ARCHITECTURAL REVIEW BOARD STAFF REPORT

Project #/Name	SE2021-25 and -26: Stonefield Town Center Block C2-1
Application/Review Type	Special Exception (first review)
Parcel Identification	061W0-03-00-019A0
Location	In the Stonefield development at the northeast corner of Bond Street and District Avenue
Zoned	Neighborhood Model District (NMD), Entrance Corridor (EC)
Owner/Applicant	OCT Stonefield Property Owner LLC/WW Associates (John Beirne)
Magisterial District	Jack Jouett
Proposal	To increase the maximum number of stories from 5 to 7 and to transfer 73 residential units from Block E to Blocks A through D to construct a 112-unit multi-family residential building, including two stories of parking at the base.
Context	Block C2-1 is part of a mixed-use development with single-story retail buildings immediately to the east and south and the 6-story Hyatt Place hotel to the west. A 5-8-story apartment building with ground-floor commercial space has been approved for the site to the southwest. The Northrup Grumman industrial site is to the north. (See Figure 1.)

Figure 1: Map showing a portion of the Stonefield development with the subject property (Block C2-1), the existing Hyatt Place Hotel (6 stories tall), and Block D1 (the site of an approved apartment building with heights of 5 – 8 stories).

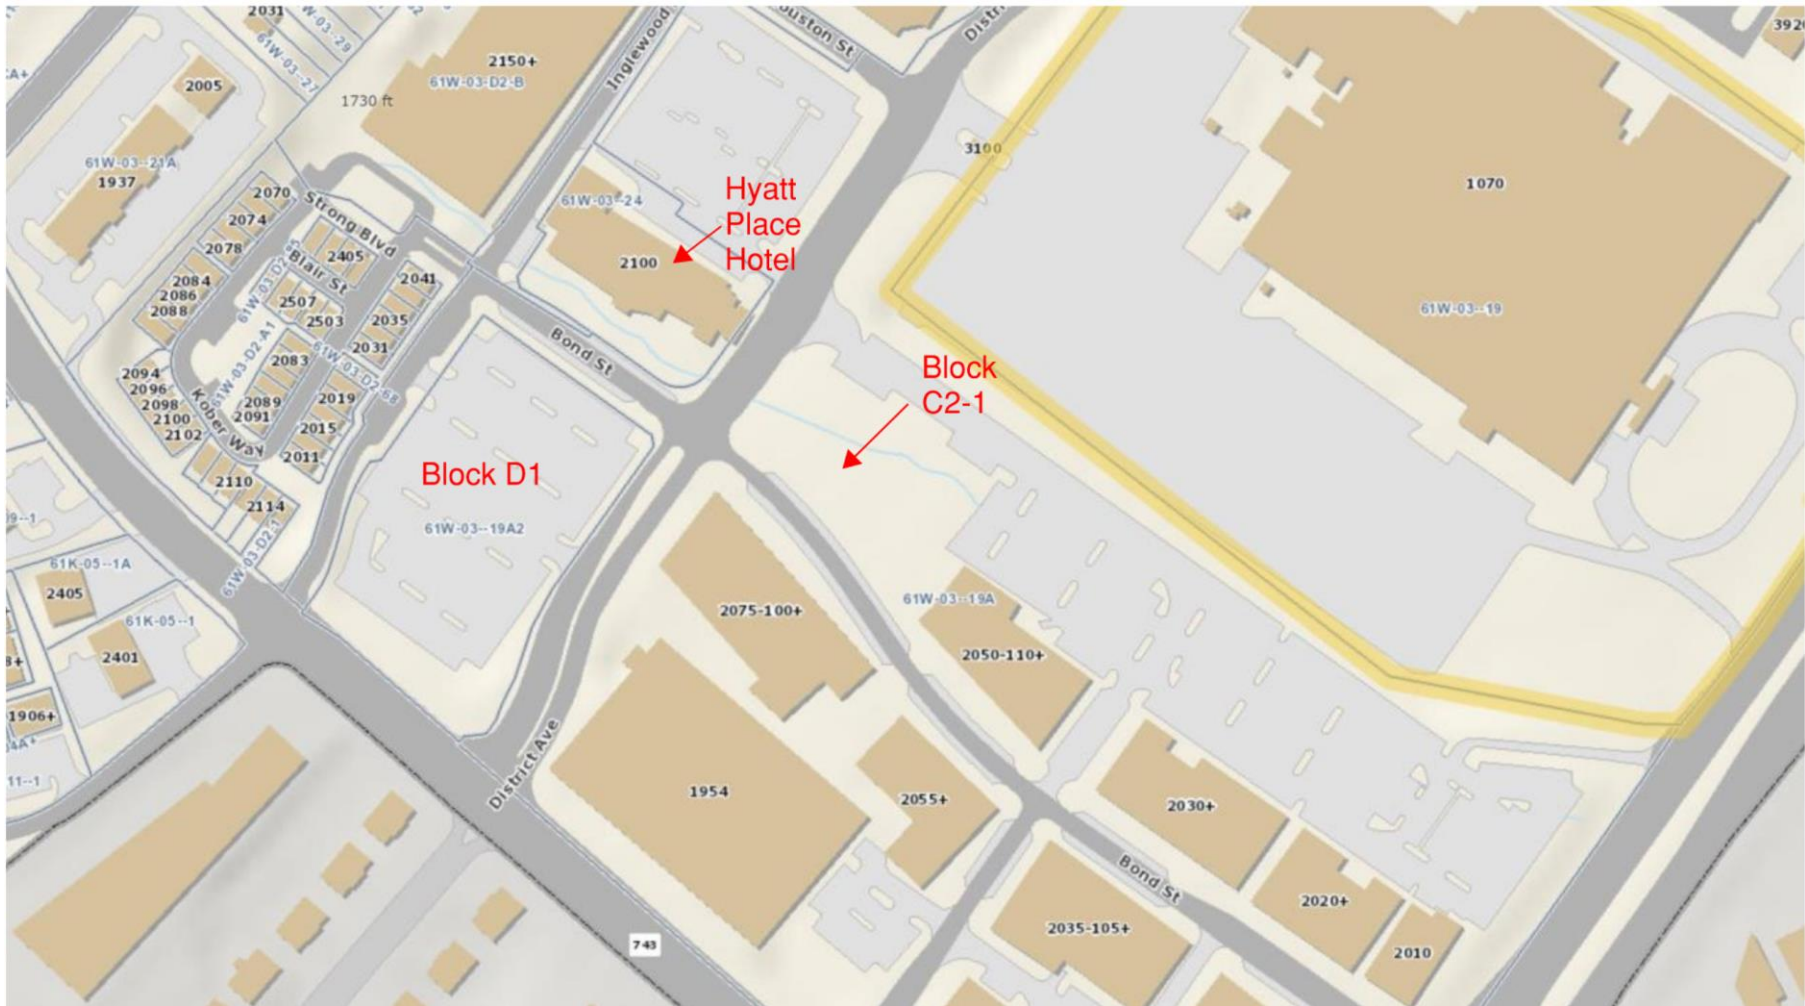
Visibility	A 7-story building in Block C2-1 will be clearly visible from Hydraulic Road until the building in Block D1 is constructed. Other buildings already constructed within the Stonefield development are expected to limit other views on Hydraulic to brief views of the upper stories of the building. The upper stories of the building are expected to have some limited visibility from Rt. 29 at a distance of approximately 800’.
ARB Meeting Date	July 19, 2021
Staff Contact	Margaret Maliszewski

10	Buildings should relate to their site and the surrounding context of buildings.	It is anticipated that a building design that is compatible with the nearby Stonefield buildings will be achievable with a 7-story building, given the height of surrounding development. Compatibility of the architecture with the surrounding context will be assessed with future site plan submittals.	
11	The overall design of buildings should have human scale. Scale should be integral to the building and site design.	Increased building height can result in a grander scale and greater visibility. This site is located approximately 800' from the Rt. 29 EC and 450' from the Hydraulic Rd. EC. It is anticipated that scale perceived at these distances can be successfully treated with breaking down of the building mass, sufficient fenestration and architectural detailing, and materials/colors. These design elements will be reviewed with future site plan submittals. The overall scale of the 7-story building is not expected to create a negative impact on the EC streets given the height and mass of existing and approved buildings in the town center, and distance from the streets.

The ARB has no objection to the Special Exceptions requested for Stonefield Block C2-1.
